UNITED STATES OF AMERICA
NUCLEAR REGULATORY COMMISSION

Advisory Committee on Reactor Safeguards
Subcommittee on Waste Management

Date: Friday, April 22, 1983

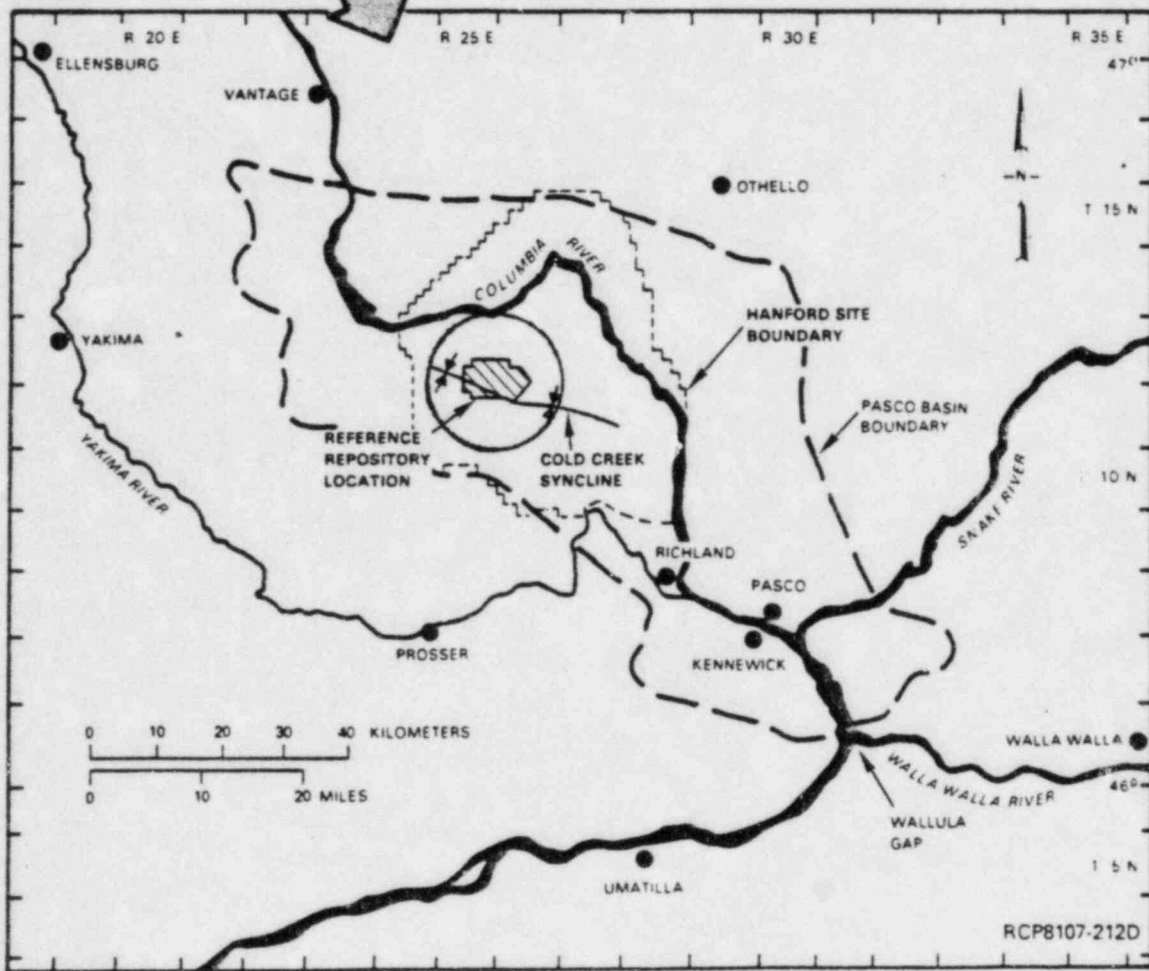
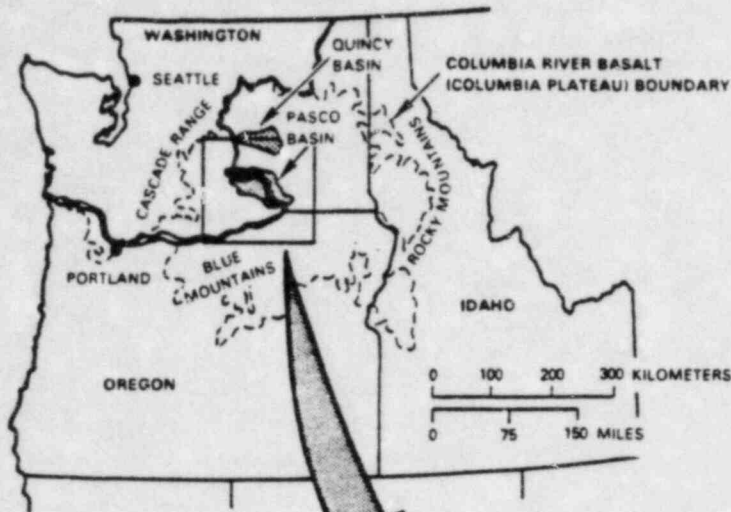
- O EXPAND THE FIELD PROGRAM, AS NECESSARY, IN STRUCTURAL GEOLOGY IN AREAS ADJACENT TO THE PASCO BASIN TO SUPPLEMENT WORK IN THE SITE AREA.

- O ESTABLISH THE MAXIMUM CREDIBLE EARTHQUAKE FOR EACH SEISMOGENIC STRUCTURE OR REGION THAT COULD AFFECT THE SITE.

- O SPECIFY THE APPROPRIATE GROUND ATTENUATION TO THE SITE.

Figure A-14 Repository cutaway (Source: SCR)

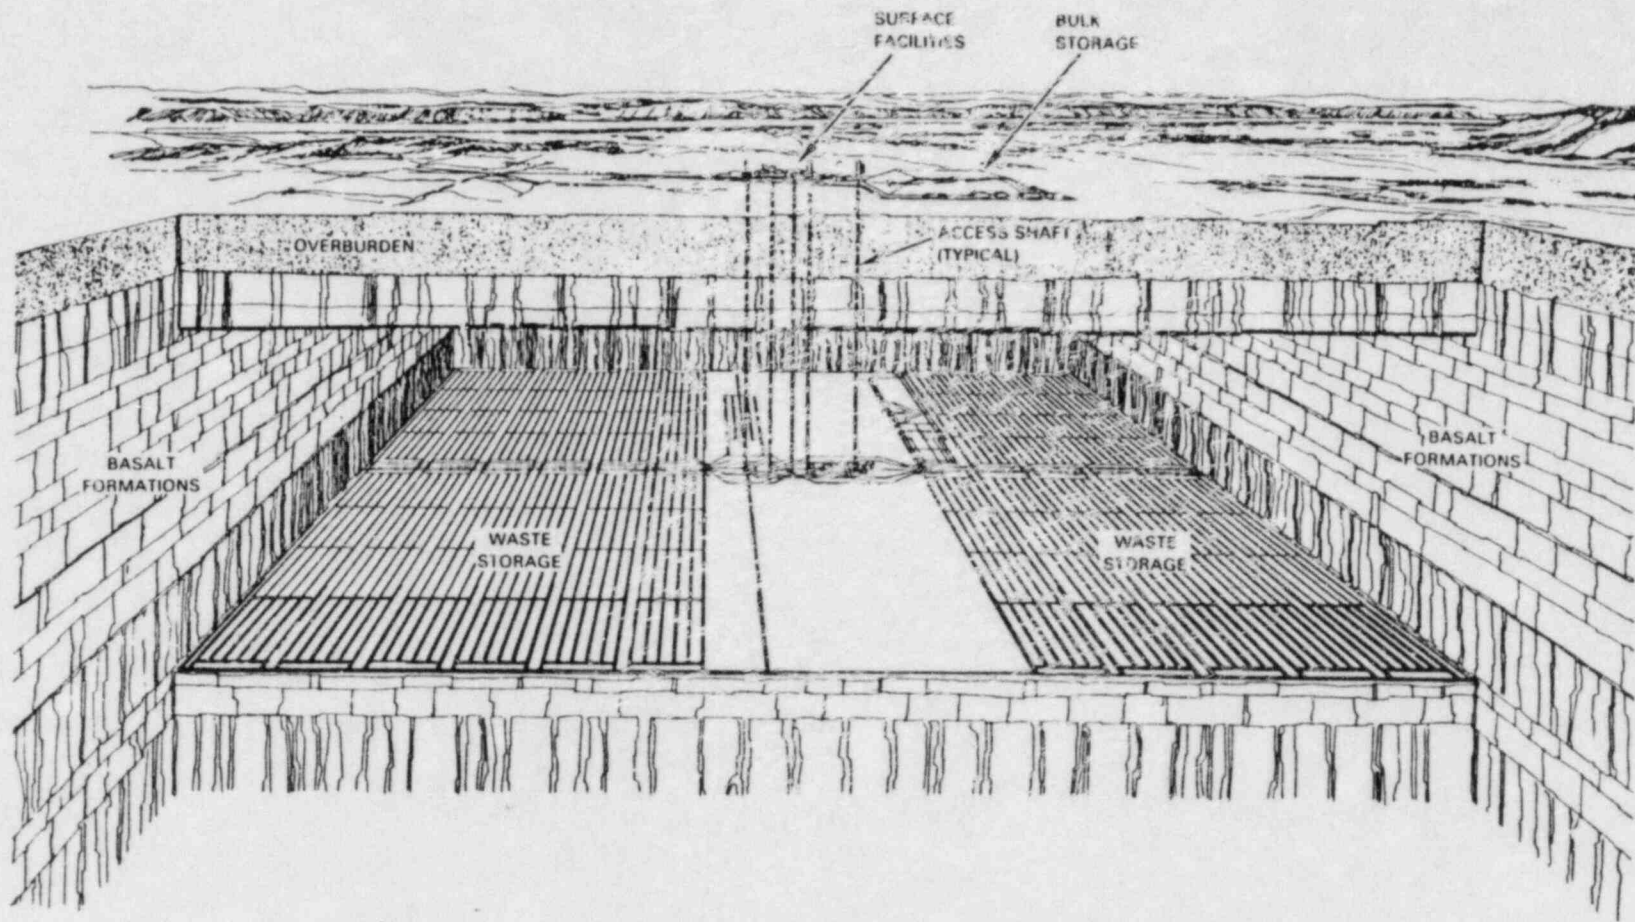
ANALYSIS OF THE ISSUES

- CONSTRUCTIBILITY OF EMPLACEMENT HOLES NEEDS TO BE ASSESSED
- TIMELY DEMONSTRATION OF RETRIEVABILITY IS NEEDED
- WORK ELEMENT PRIORITIES NEED TO BE UPGRADED
